114 MULBERRY, MANHATTAN, NY

PROJECT 114 Mulberry

Project:
114 Mulberry ShopDrawing

Description:
Windows Alumil M11500

DRAWING TITLE:
TITLE SHEET

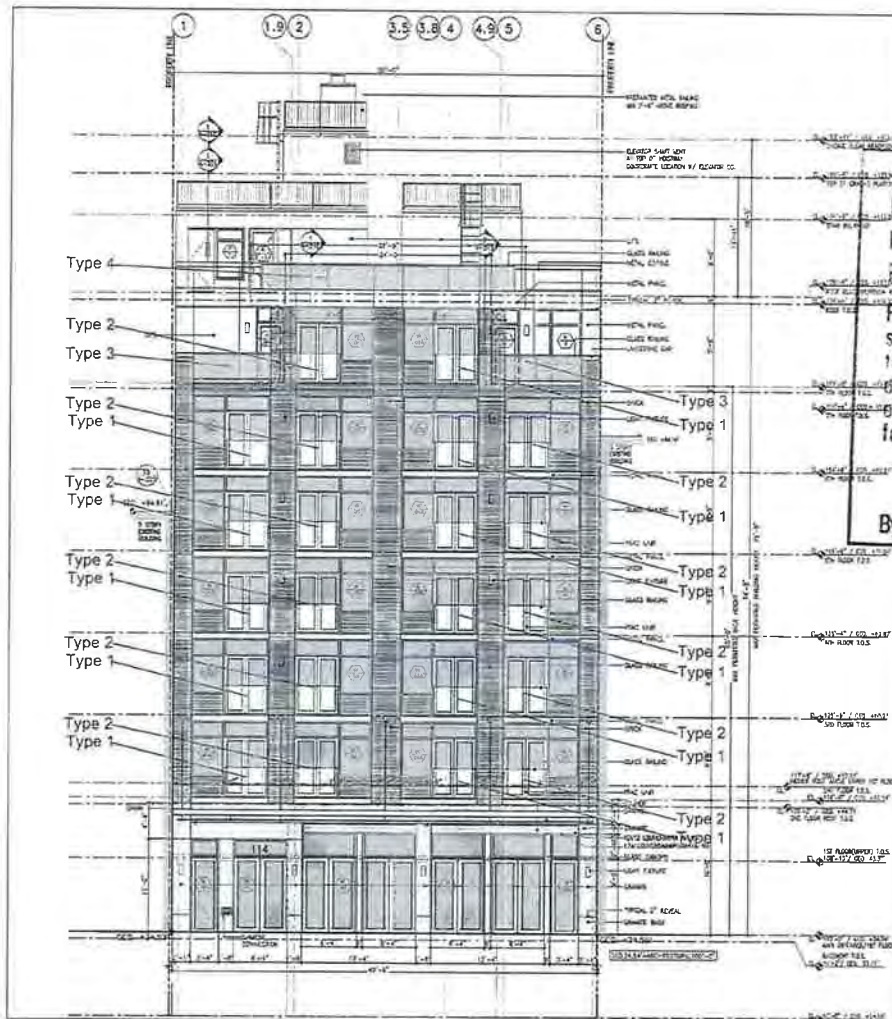
NOTE: - FOLLOW RCM COMMENTS

- GLASS RAILING TO COMPLY WITH NYC BC 2407.1

- C.I.M TO VERIFY ALL DIMENSIONS PRIOR TO FABRICATION

EM COORDINATE BALCONY RAILING / FRENCH BALCONIES WITH DOORS.
